CONSIDERATION OF AND/OR ANY APPROPRIATE ACTION ON PANORAMA STREET PRELIMINARY PLAT, SITUATED IN THE PHILLIP ANDERSON SURVEY, ABSTRACT NO. 10 CITY OF PARKER, COLLIN COUNTY, TEXAS. [MACHADO]

Re: Panorama Street
 Preliminary Plat and Engineering Plan Review

As you requested, we have reviewed the Preliminary Plat & Engineering Plans for the Panorama Street Addition prepared by LJA Engineering, Inc. These documents include a new street and is therefore considered a major subdivision under section 155.025 of subdivision ordinance.

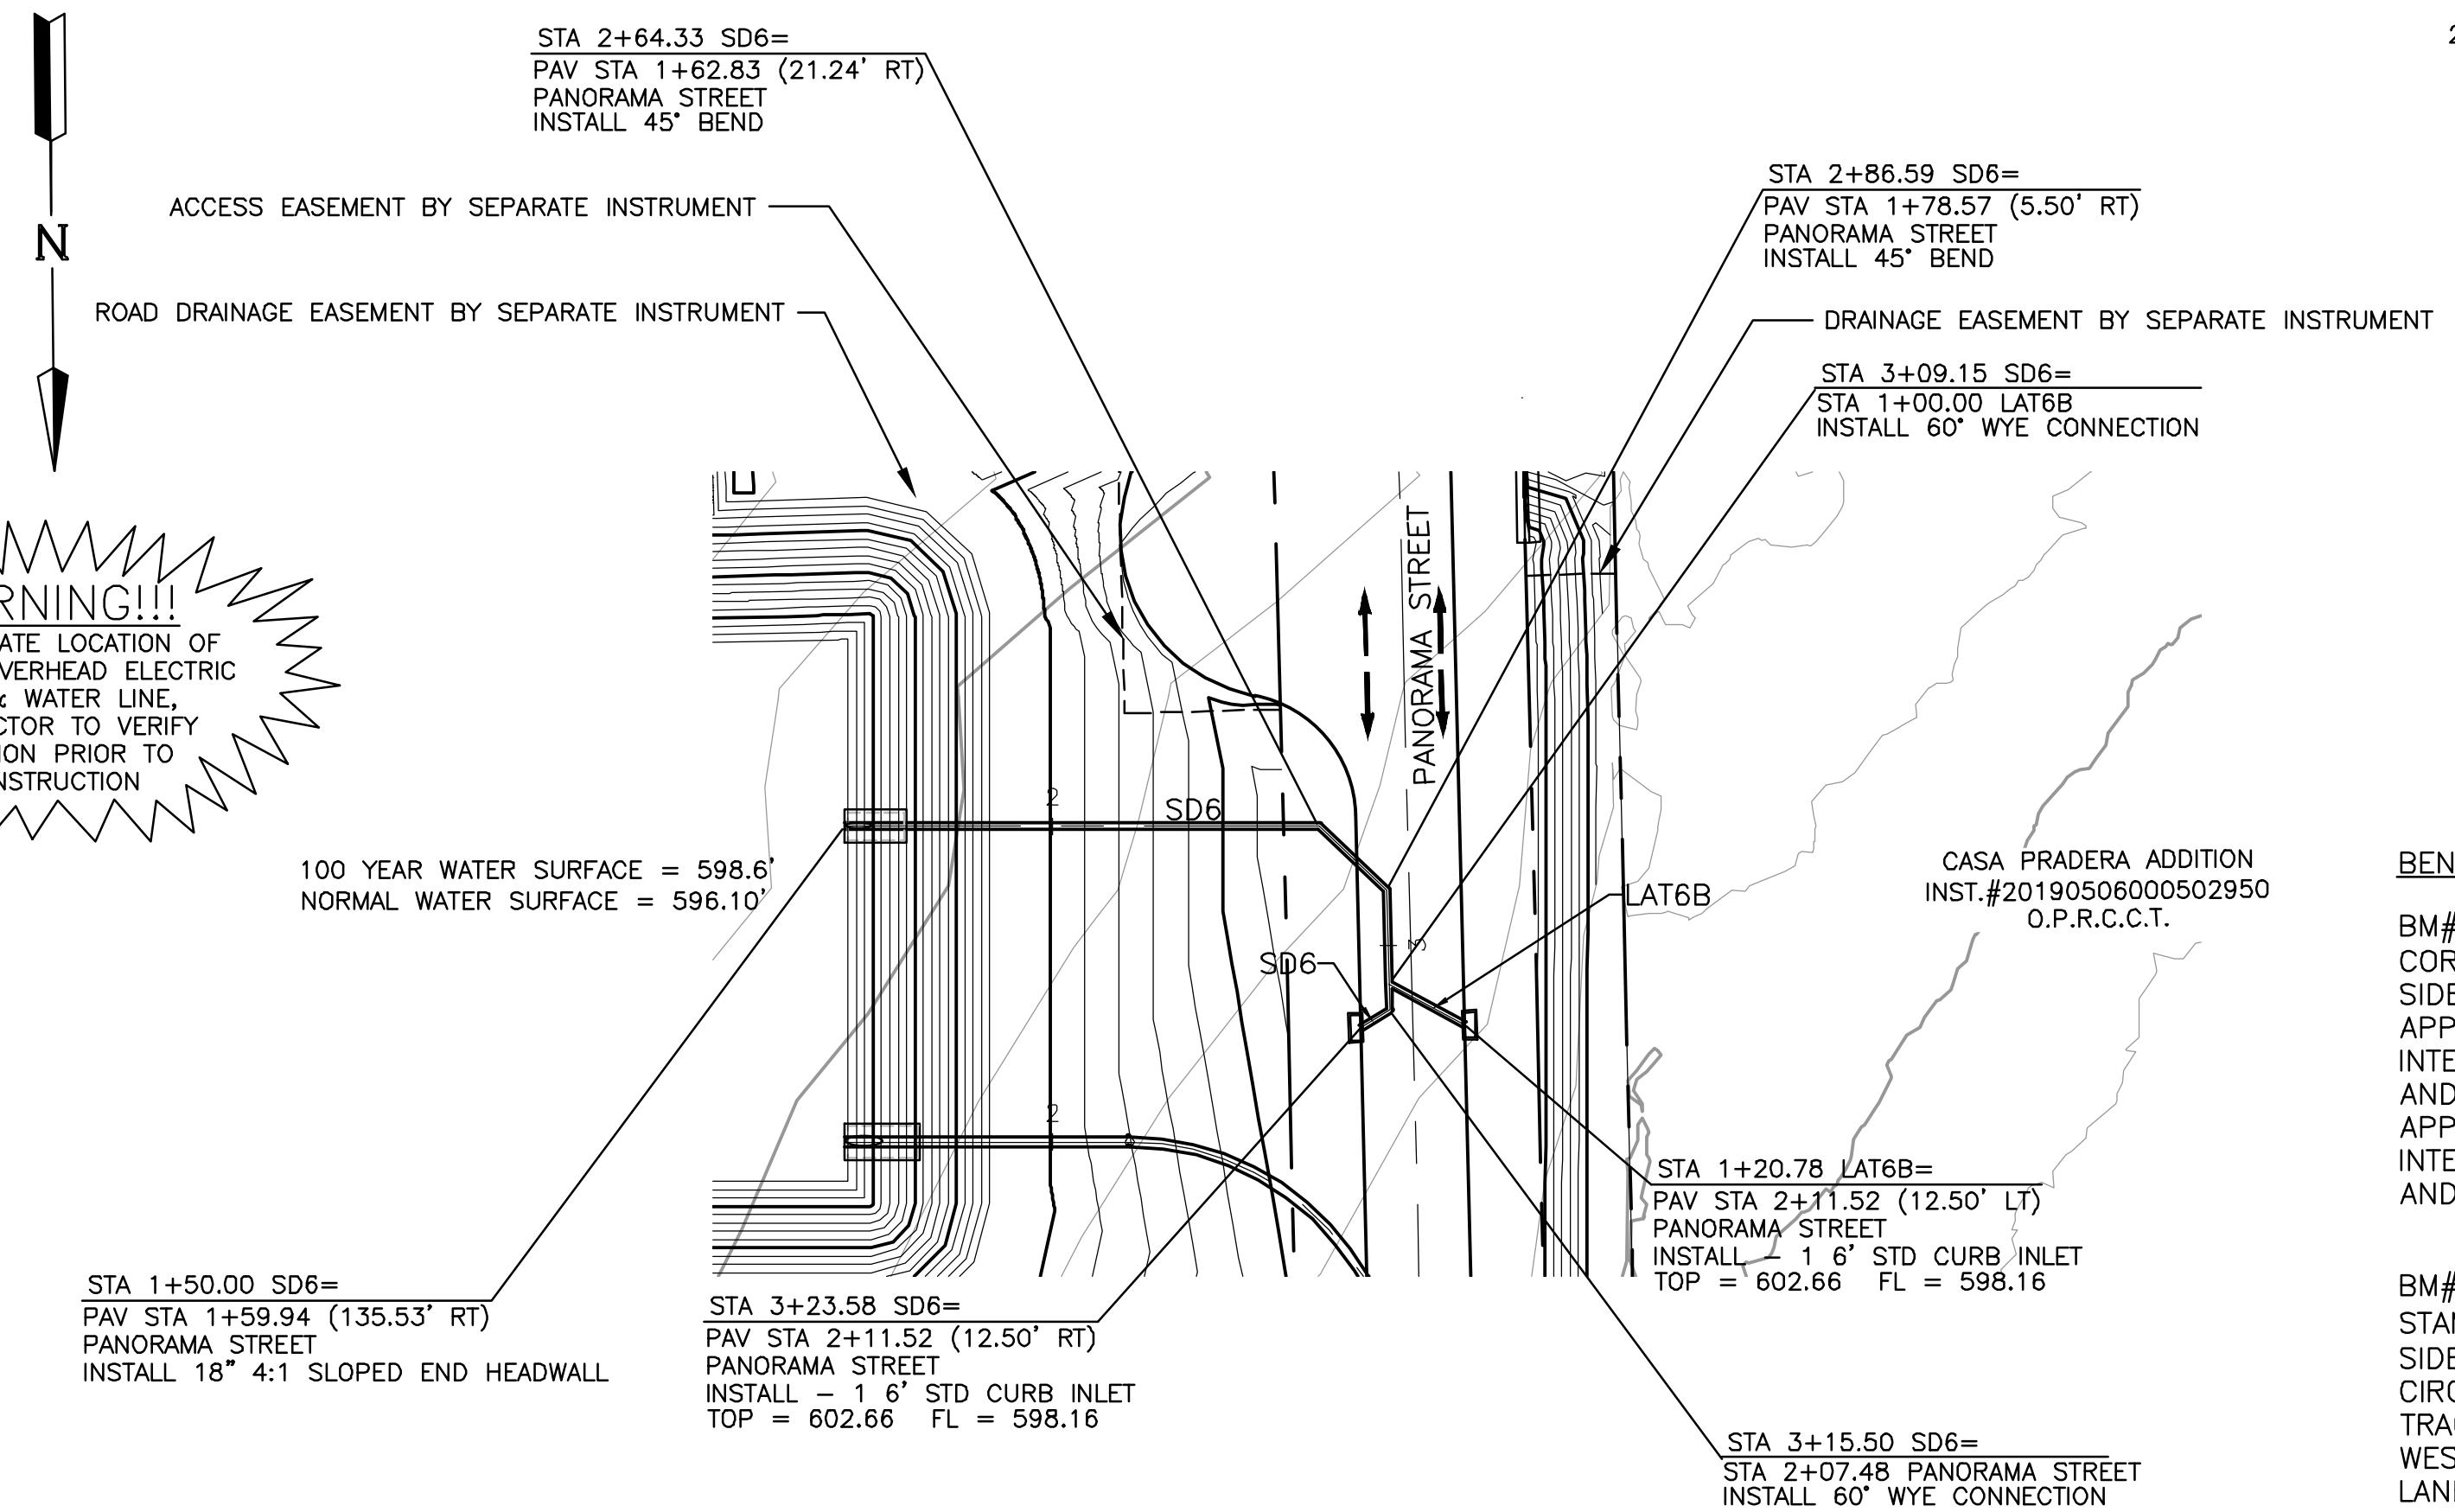
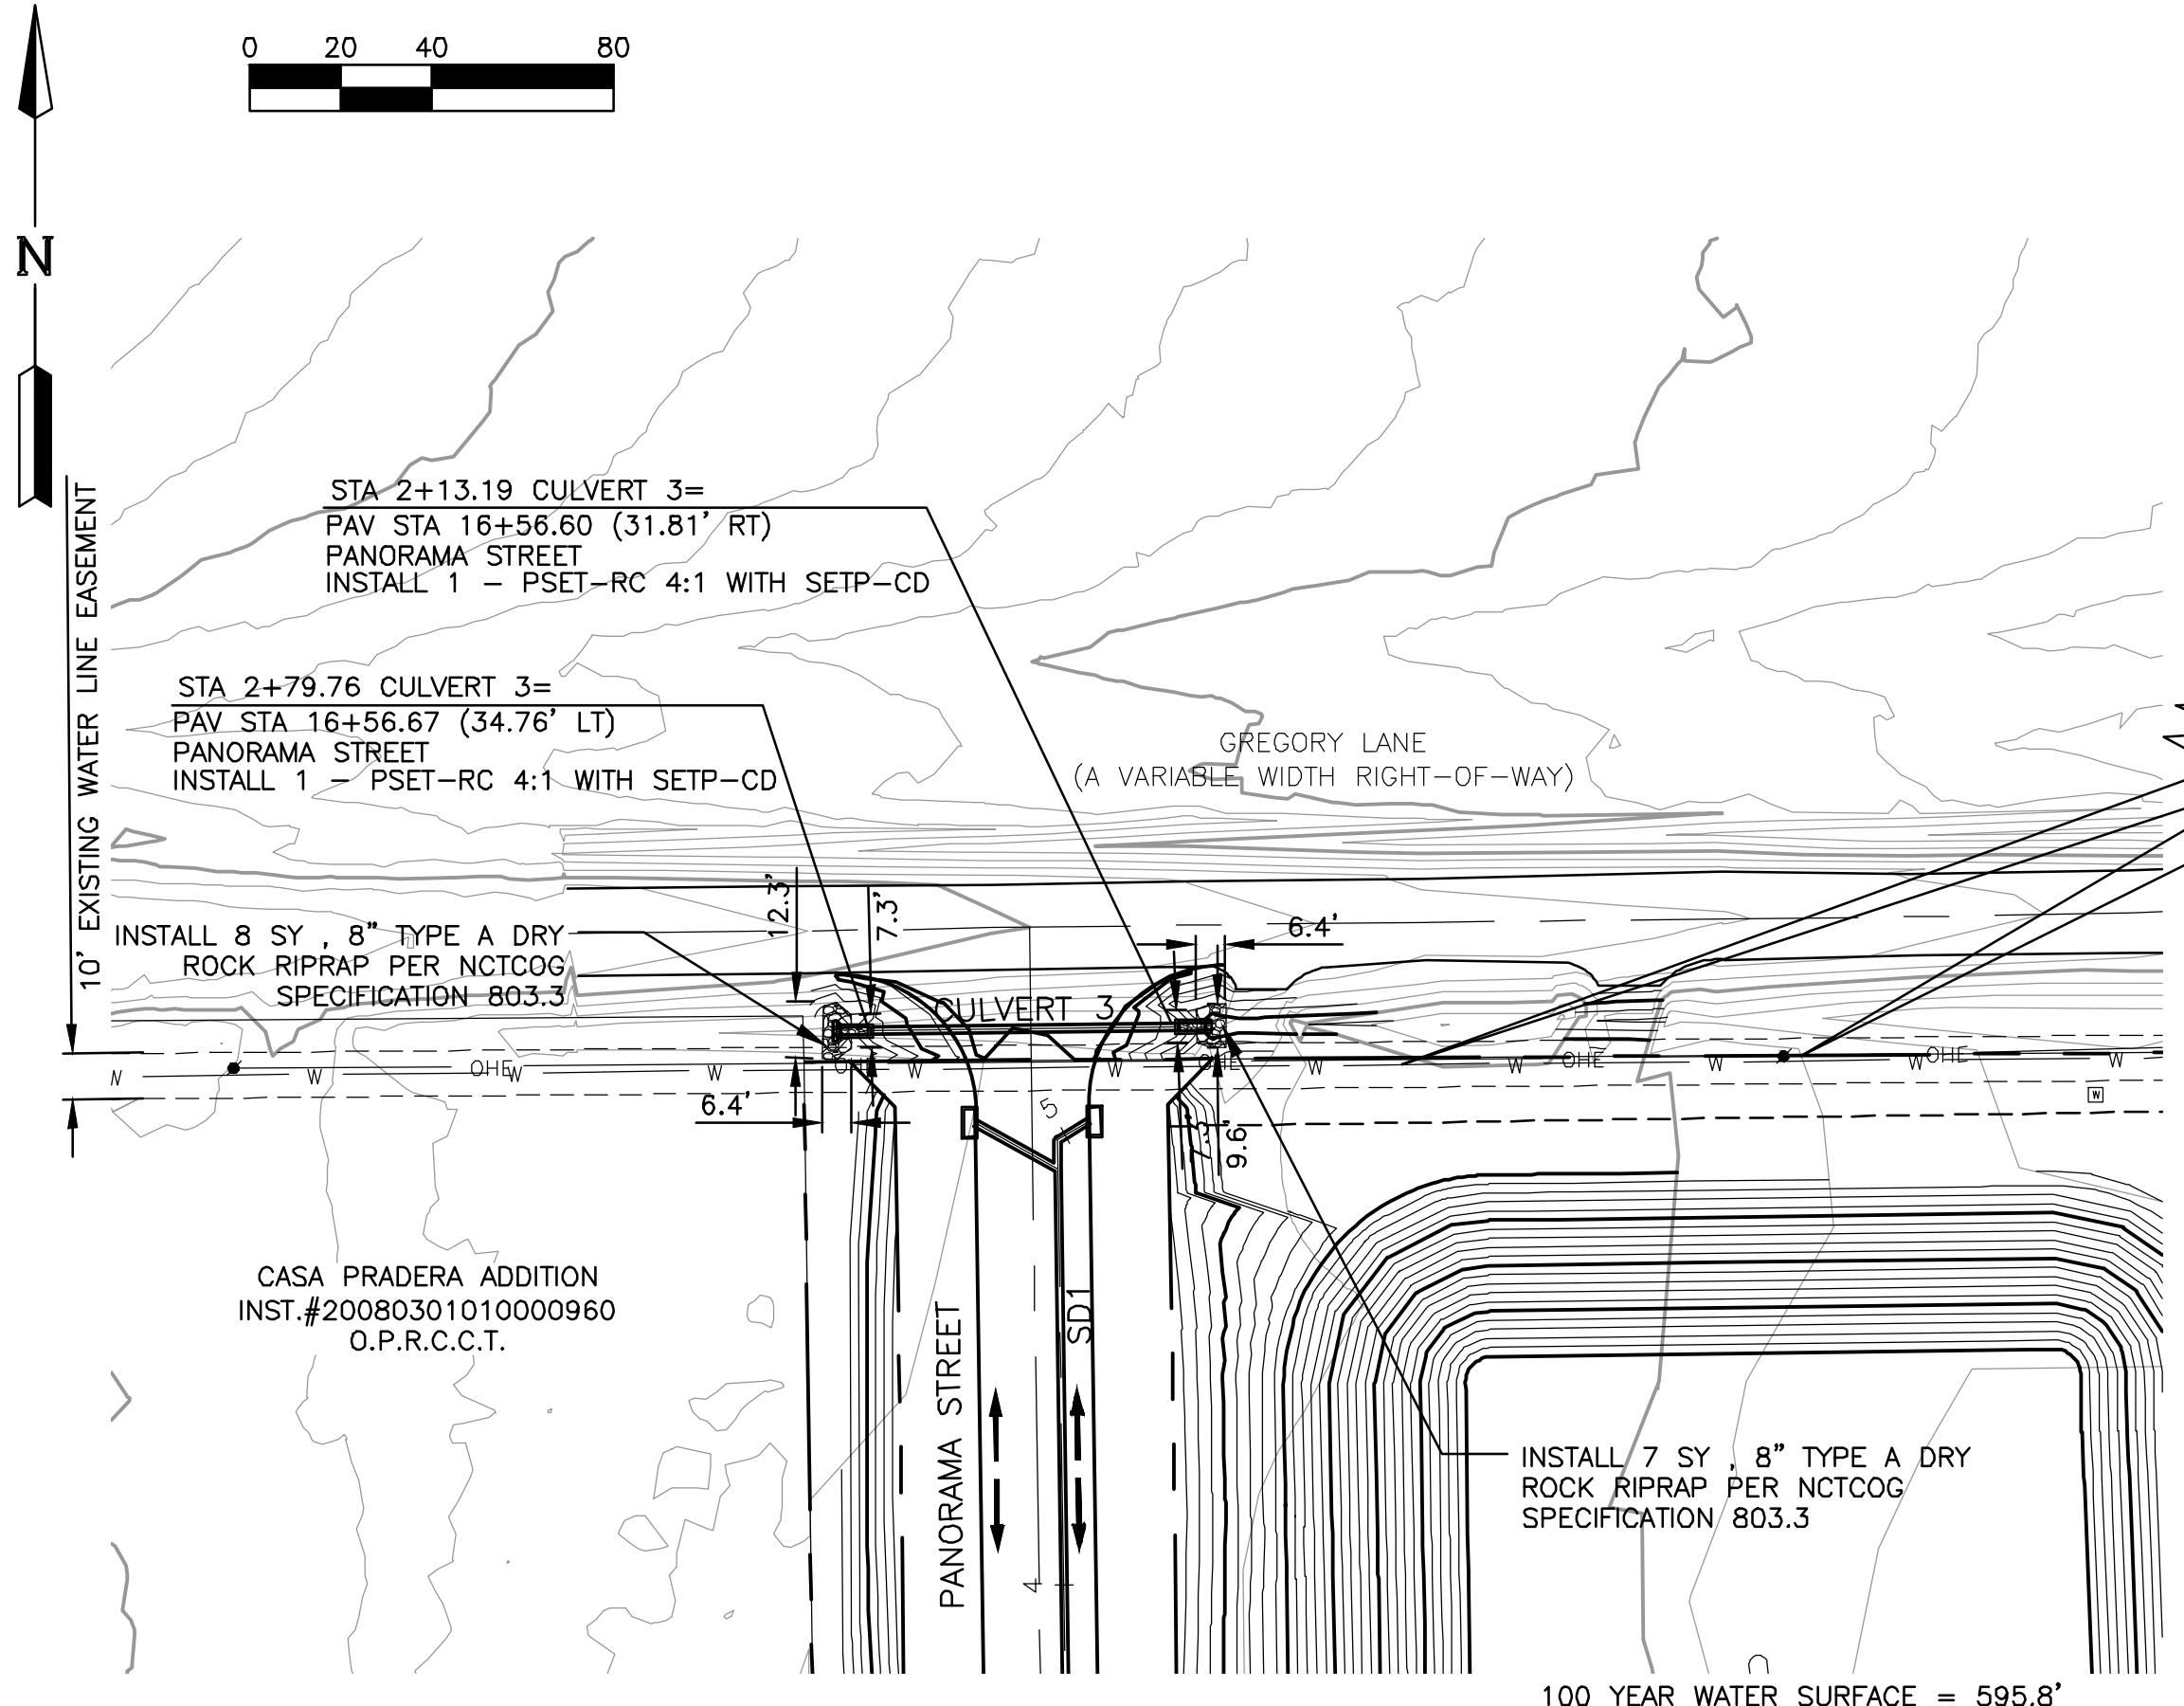
47. Sheet 20 Show depth of rip rap and geotextile fabric as foundation.
48. Sheet 20 Culvert 3 section does not correspond to what is called out in the plan view.

49. Sheet 20 Provide ASTM call out for RCP.
50. Sheet 20 Utilize radius pipe and eliminate bends.
51. Sheet 20 show footer at end of SD6.
52. Sheet 20 The call out in plan view for SD6 and Lateral 6B appear reversed to correspond with the section.
